84 MARGINAL WAY

Mark	Date	Description
–	06.22.07	REVISION 1
–	05.08.07	ISSUED FOR CONSTRUCTION
–	03.26.07	100% DESIGN DEVELOPMENT

GRADING, DRAINAGE AND UTILITIES PLAN

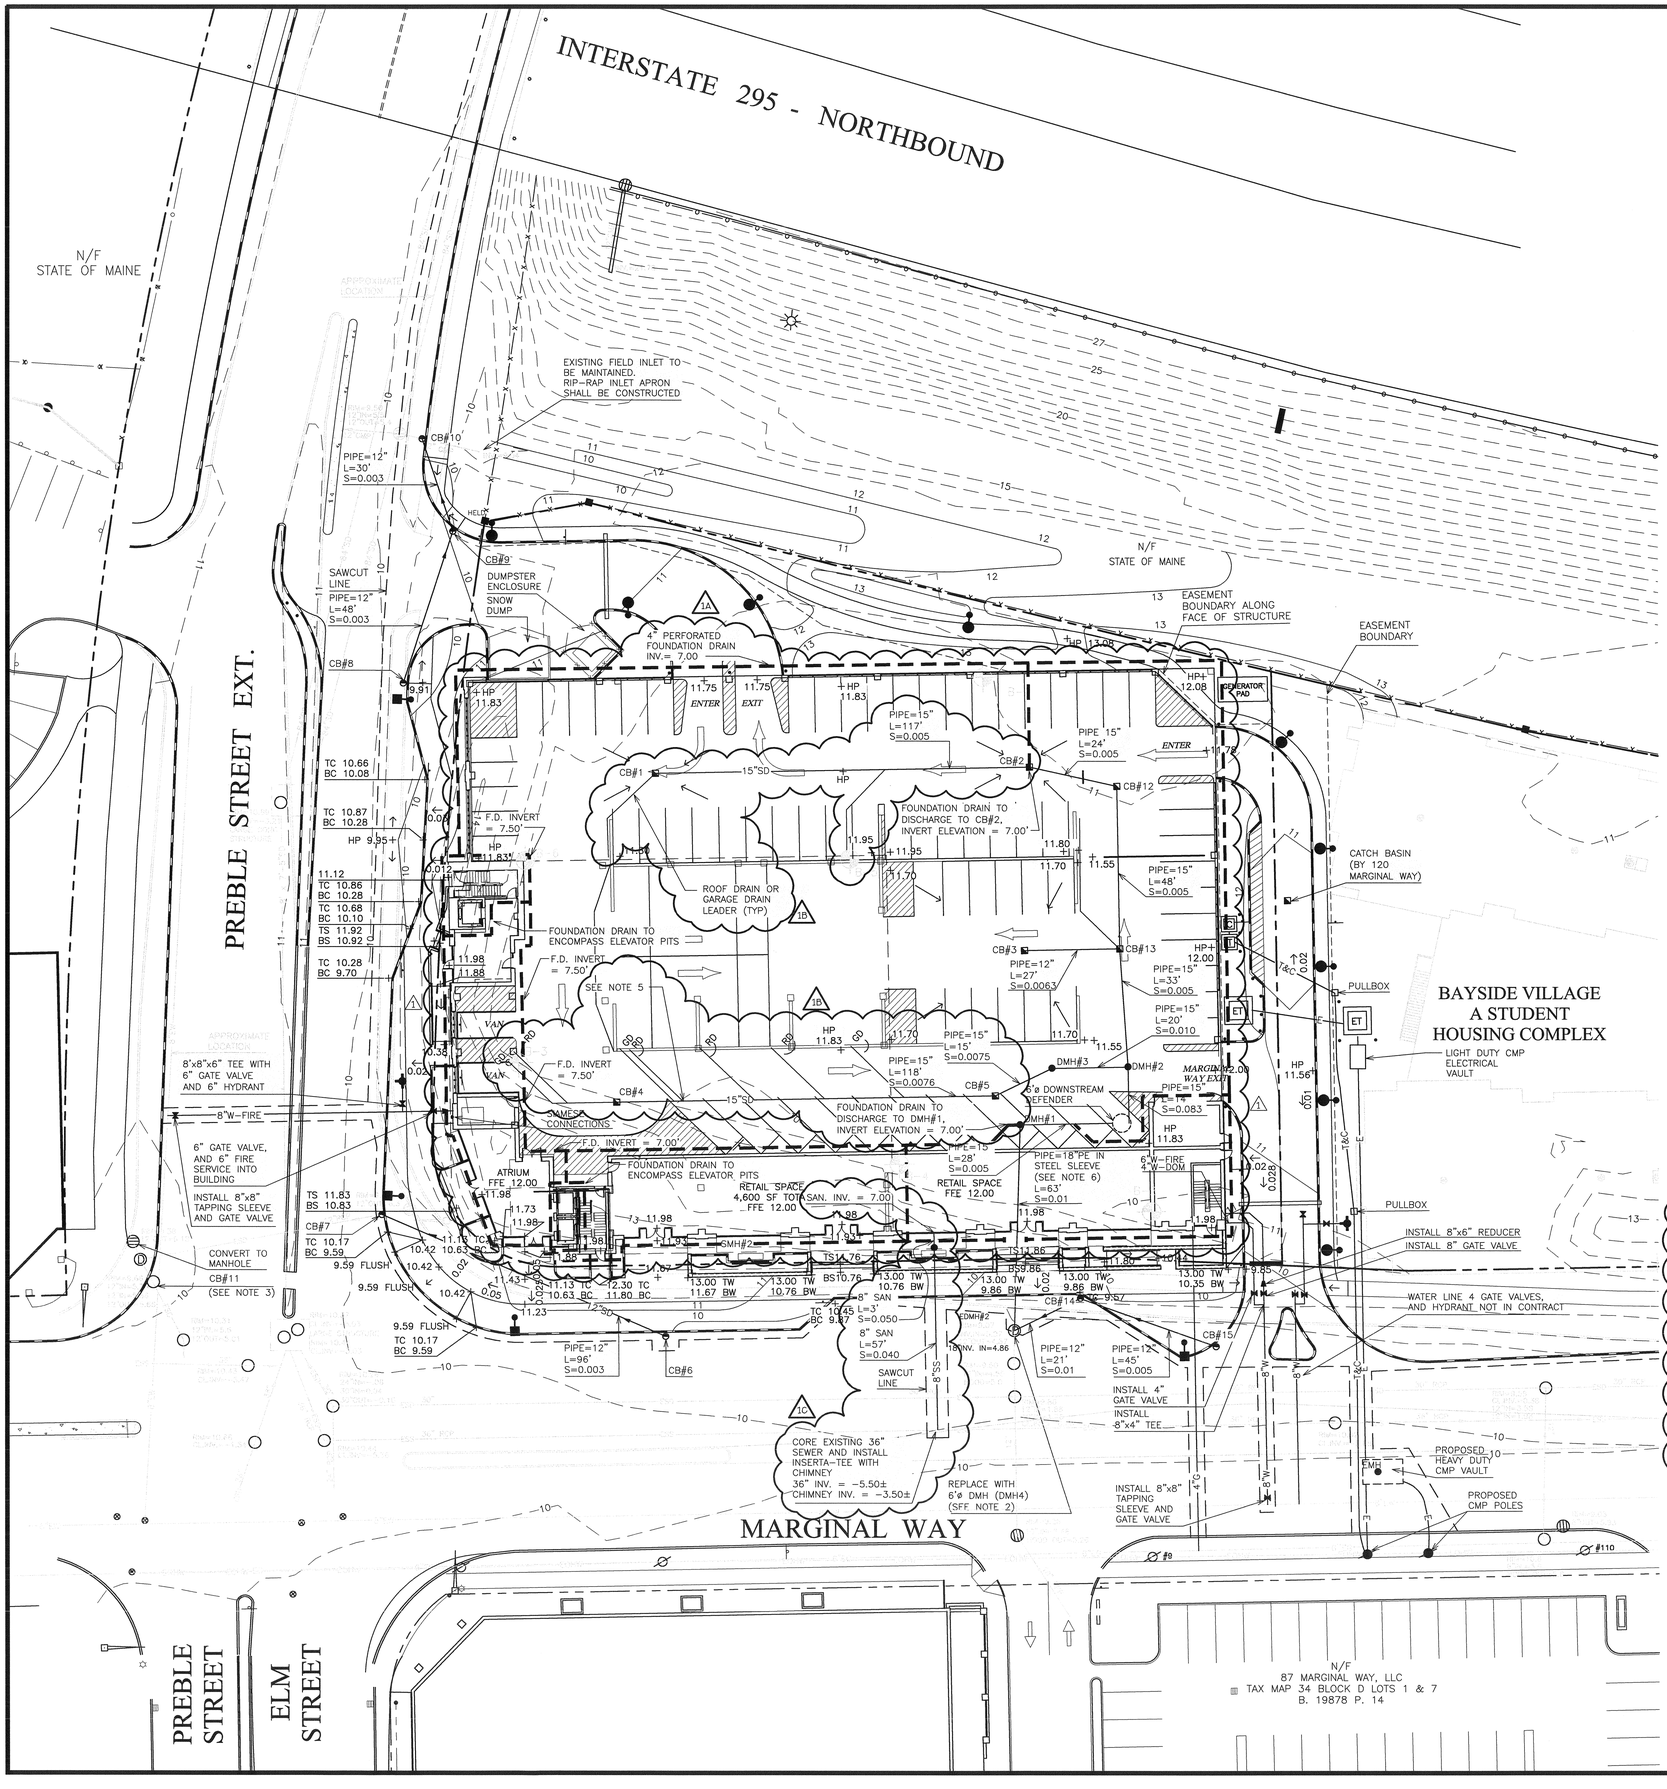
- A PLAN REVISION – 4' FOUNDATION UNDERDRAIN AROUND PERIMETER OF BUILDING AND PERIMETER OF STRUCTURAL SLAB REGIONS OF THE BUILDING. FOUNDATION DRAIN SHALL OUTLET TO DMH#1 AND CB#2 AND BE CONSTRUCTED WITH AN INVERT OF 7.00'. FOUNDATION DRAIN SHALL ALSO CONNECT TO THE 15' SD PIPE LOCATED DOWNSTREAM OF THE WATER QUALITY UNIT USING A 15"x4" WYE FITTING AS SHOWN ON THE ROOF/GARAGE DRAIN CONNECTION DETAIL. REFER TO FOUNDATION DRAIN DETAIL.

- B PLAN REVISION – ROOF DRAIN AND GARAGE DRAIN PIPE HEADERS HAVE BEEN REVISED. ROOF DRAIN AND GARAGE DRAIN CONNECTIONS TO THE STORM DRAIN PIPE SHALL BE MADE USING LATERAL WYE CONNECTIONS. WYES SHALL BE INSTALLED WITH A MINIMUM 1% SLOPE TOWARD THE STORM DRAIN PIPE. ALL JOINTS SHALL BE WATER-TIGHT. ROOF DRAIN LEADERS SHOWN CONNECTING TO CATCH BASINS SHALL ENTER THE STRUCTURE WITH AN INVERT AT OR ABOVE THE INVERT OUT ELEVATION. ROOF AND GARAGE DRAIN SIZE, LOCATION AND CONNECTIONS SHALL BE COORDINATED WITH BUILDING AND FOUNDATION PLANS. REFER TO ROOF/GARAGE DRAIN CONNECTION DETAIL.

- C PLAN REVISION – SANITARY SEWER SERVICE CONNECTION TO MUNICIPAL SYSTEM HAS BEEN REVISED SINCE ISSUED AS SK-3 DUE TO TRAFFIC CONTROL RESTRICTIONS AS INDICATED BY THE CITY OF PORTLAND. THE REVISED SANITARY SEWER SERVICE SHALL EXIT THE BUILDING CENTERED BETWEEN ARCHITECTURAL GRIDLINES 7 + 8, WHICH IS 15 FEET ON CENTER FROM EITHER GRIDLINE. SMH #2 SHALL MAINTAIN SAME INVERTS AS NOTED ON SK3. THOUGH SANITARY PIPE SLOPE OUT OF THE MANHOLE SHALL BE CONSTRUCTED AT 4.0% SLOPE OR AS NECESSARY TO MAINTAIN 1 FOOT OF VERTICAL SEPARATION ABOVE THE 30-INCH MUNICIPAL STORM DRAIN LOCATED IN MARGINAL WAY. ONCE BEYOND THE STORM DRAIN, THE SANITARY SEWER SERVICE SHALL CHIMNEY DOWN TO THE 36-INCH SEWER MAIN AS SHOWN IN THE DETAIL ON SK-3. SMH #3 SHALL BE CONSTRUCTED AS A SEALED MANHOLE.
